SUBJECT:  
Perry Nuclear Power Plant  
Docket No. 50-440, License No. NPF-58  
Mid-Cycle Revision to the Core Operating Limits Report for Operating Cycle 19

PERRY NUCLEAR POWER PLANT	Procedure Number: PDB-F0001	
Title: Core Operating Limits Report for the Perry Nuclear Power Plant Unit 1 Cycle 19 (Reload 18)	Use Category: In-Field Reference	
	Revision: 31	Page: 1 of 24

## CORE OPERATING LIMITS REPORT FOR THE PERRY NUCLEAR POWER PLANT UNIT 1 CYCLE 19 (RELOAD 18)

Rev. 31 - Updated to incorporate the required adjustments to Operating Limit MCPR as identified in Condition Report 2021-04775, Safety Communication SC 21-04, Revision 1, Fuel Support Side Entry Orifice Meta-Stable Flow for 2 Beam Locations in the BWR/6 Reactors.

**Figure 3.2.2-1**  
**Flow Dependent MCPR Limit (MCPR<sub>f</sub>)**  
**Equipment in Service**  
**Pressure Regulator Out of Service**  
**Power Load Unbalance Out of Service**

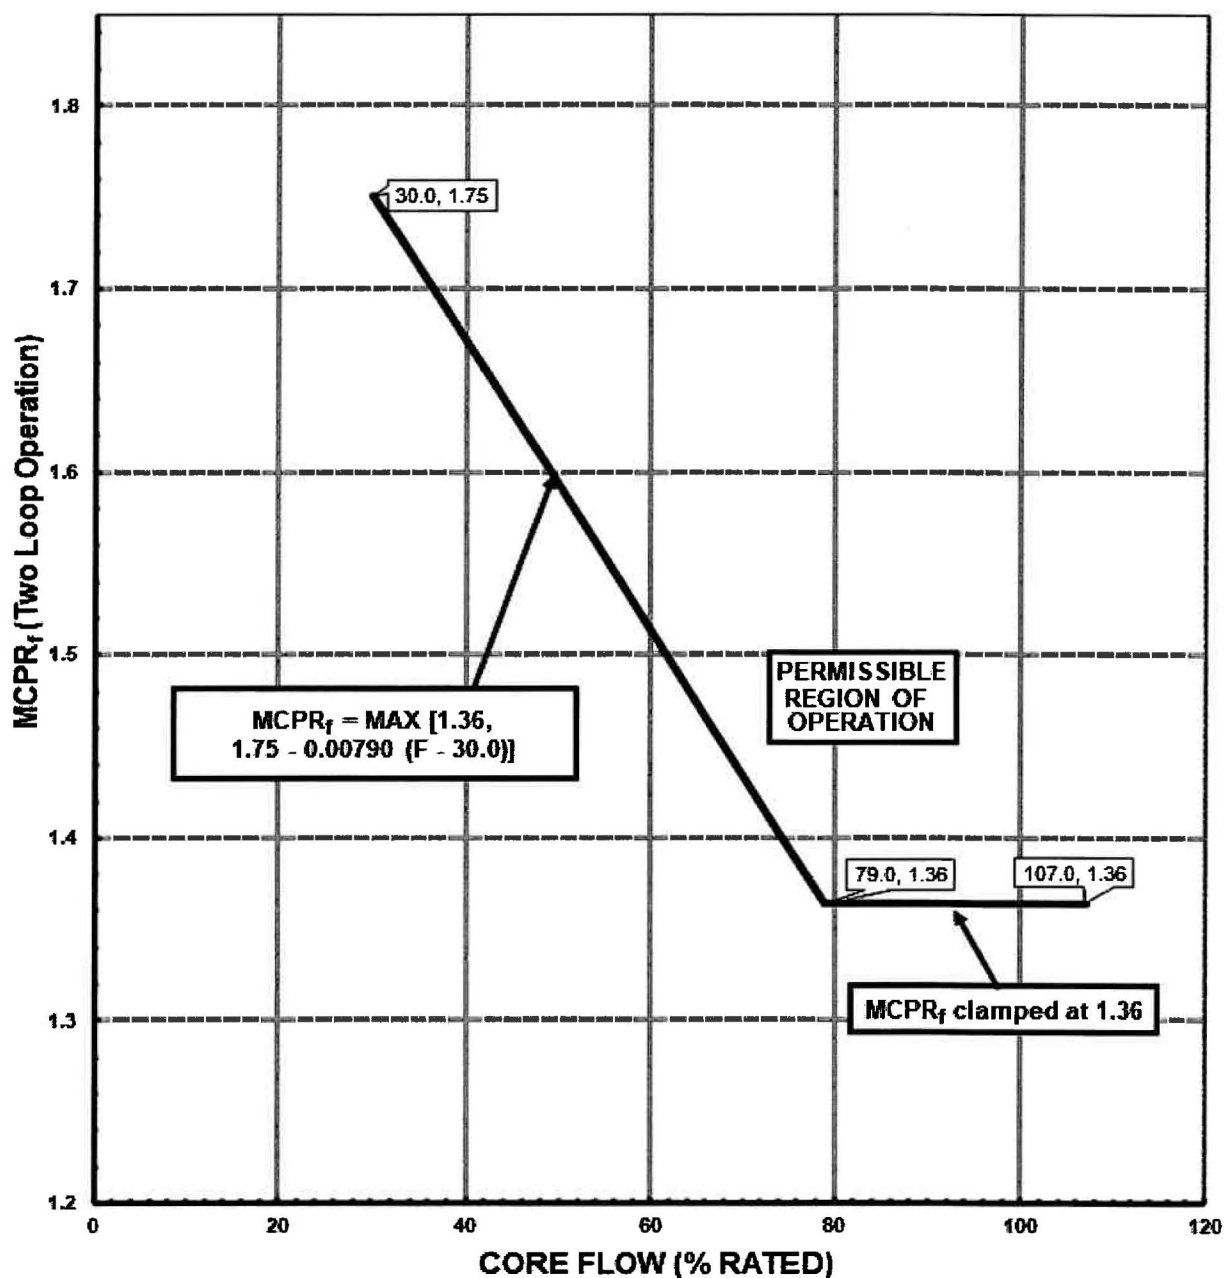
MCPR<sub>f</sub> values were adjusted as required by SC 21-04 Revision 1.

1. Operating Limit MCPR was changed from 1.31 (BOC to MOC) and 1.37 (MOC to EOC) to 1.37 (BOC to MOC) and 1.44 (MOC to EOC) as described in SC 21-04 Revision 1.
2. The  $MCPR_f$  values were updated as described in SC 21-04 Revision 1.
3. The  $MCPR_p$  values  $\leq 38\%$  RTP (EIS, PROOS, and PLUOOS) and  $K_p$  values (EIS, PROOS, and PLUOOS) were updated as described in SC 21-04 Revision 1.
4. The Delta CPR value between Two Loop Operating OL-MCPR and Single Loop Operating OL-MCPR was increased from 0.02 to 0.03.

**Figure 3.2.2-2  
Power Dependent MCPR Limit (MCPR<sub>p</sub>)  
Equipment in Service**

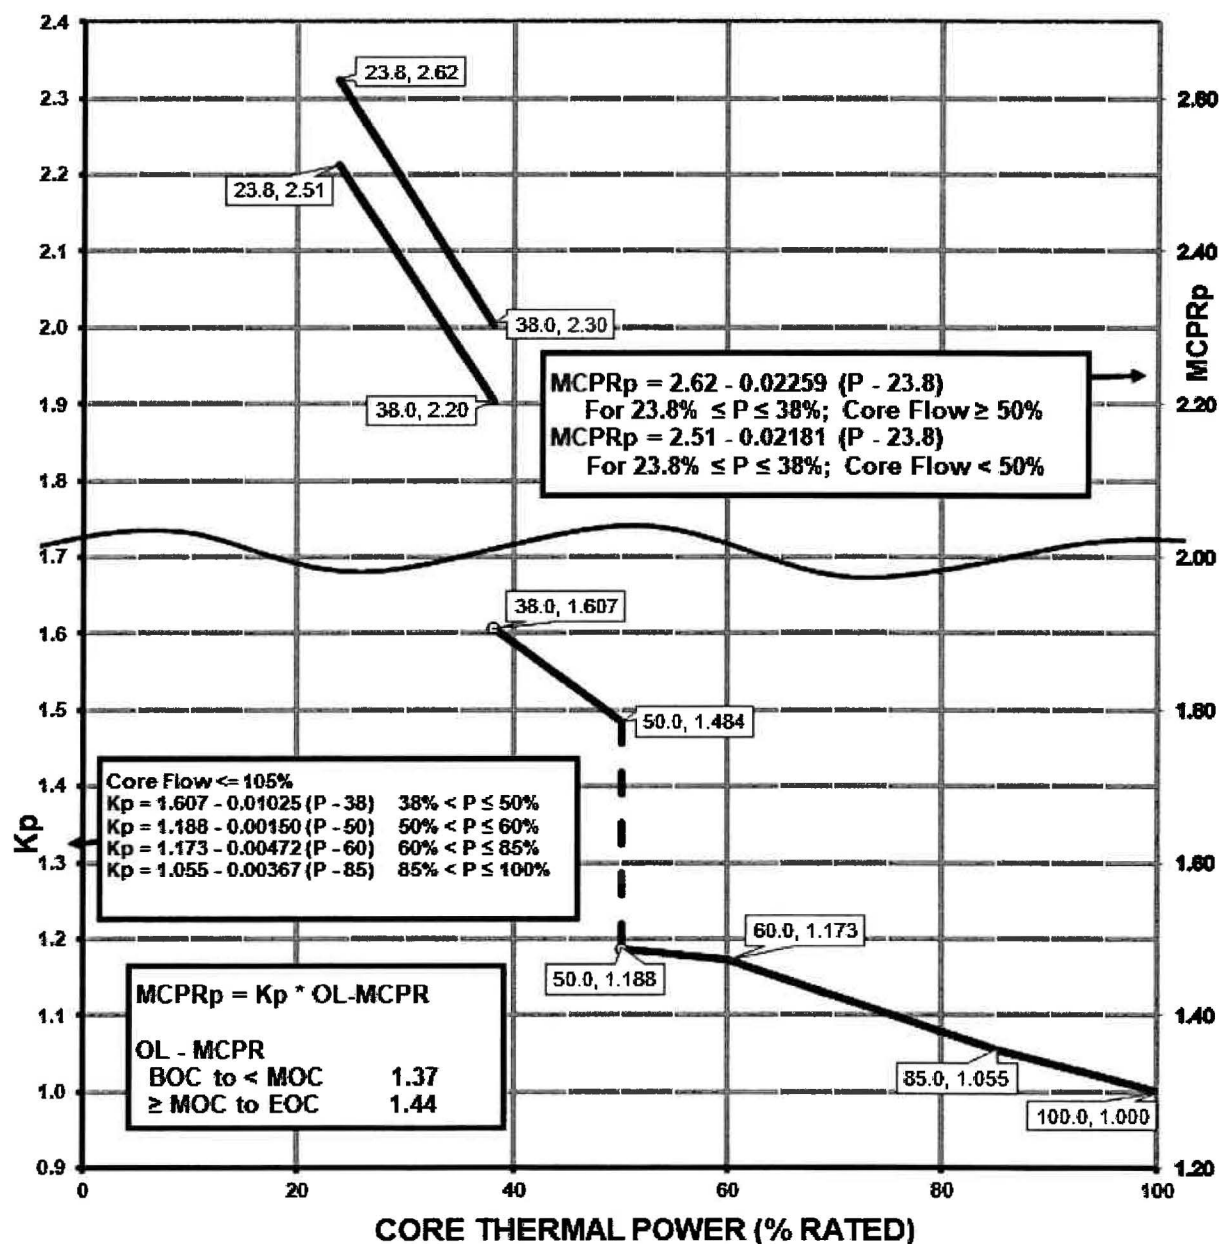
MCPR<sub>p</sub> (below or equal to 38% RTP) values were adjusted as required by SC 21-04 Revision 1.

The K<sub>p</sub> values were adjusted as required by SC 21-04 Revision 1.
